**FINAL DRAINAGE REPORT  
FOR  
MVEA YODER ELECTRIC SUBSTATION  
EL PASO COUNTY, COLORADO**

**SEPTEMBER 2018**

**FINAL DRAINAGE REPORT  
FOR  
MVEA YODER ELECTRIC SUBSTATION**

EXISTING DRAINAGE MAP

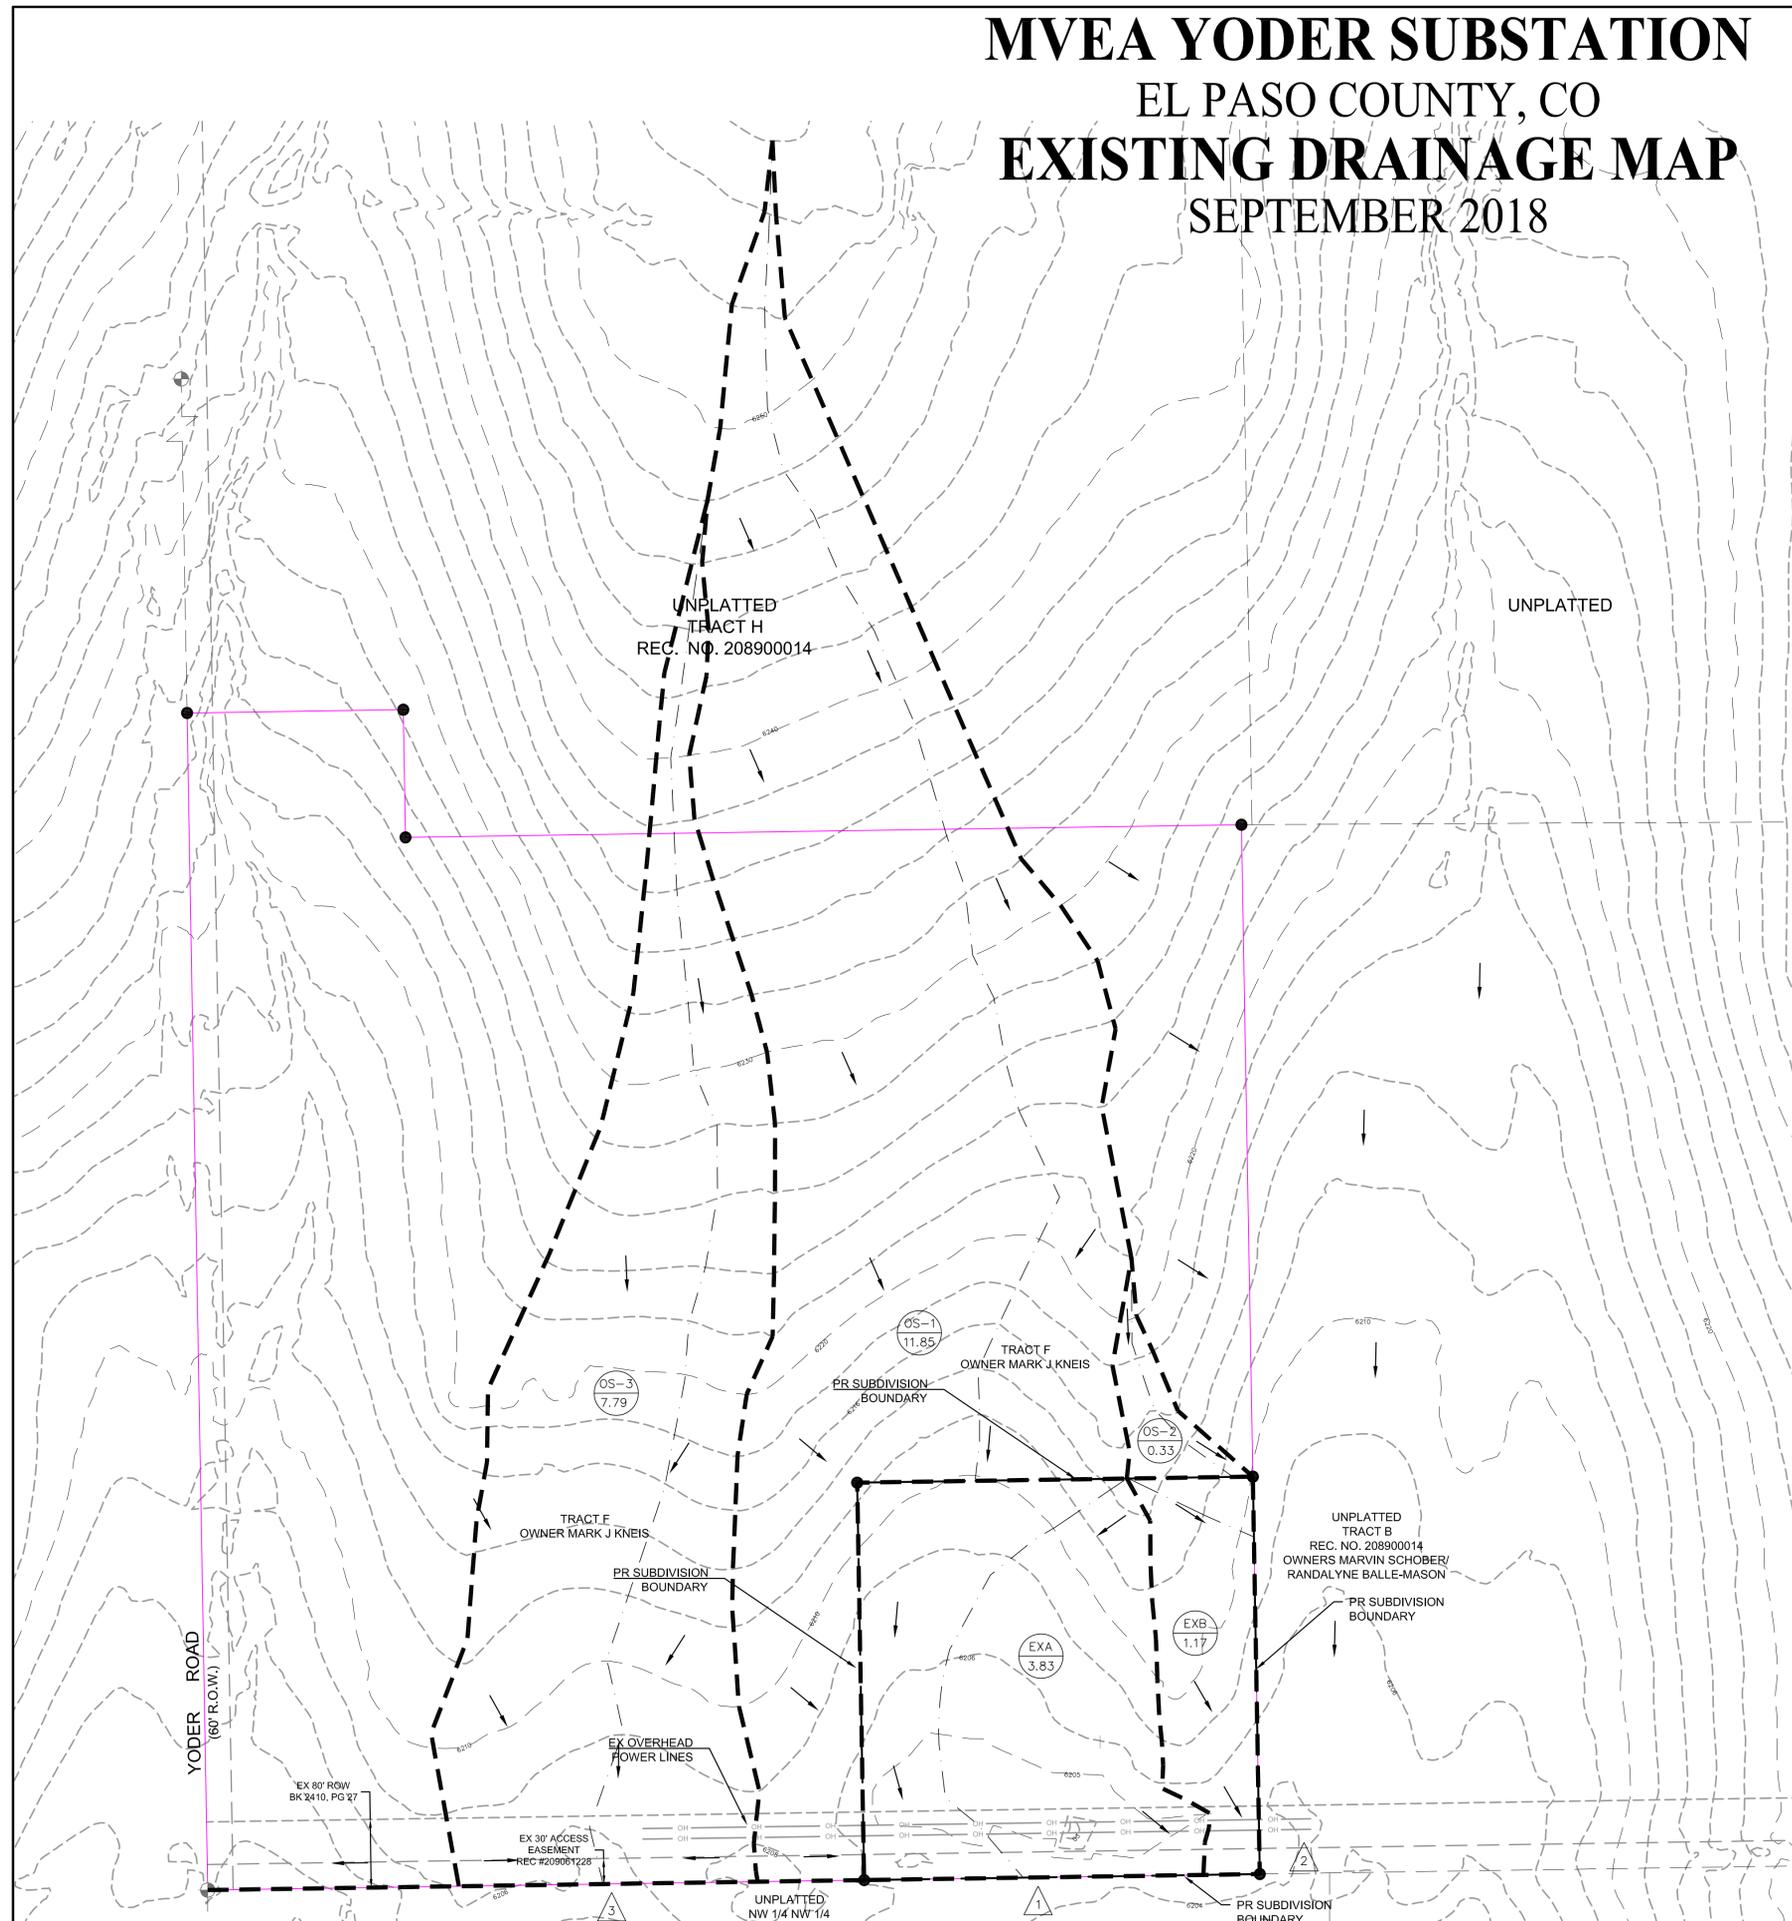
This table shows the existing conditions. The table name should be "existing conditions" not "proposed conditions".

This table shows the existing conditions. The table name should be "existing conditions" not "proposed conditions".
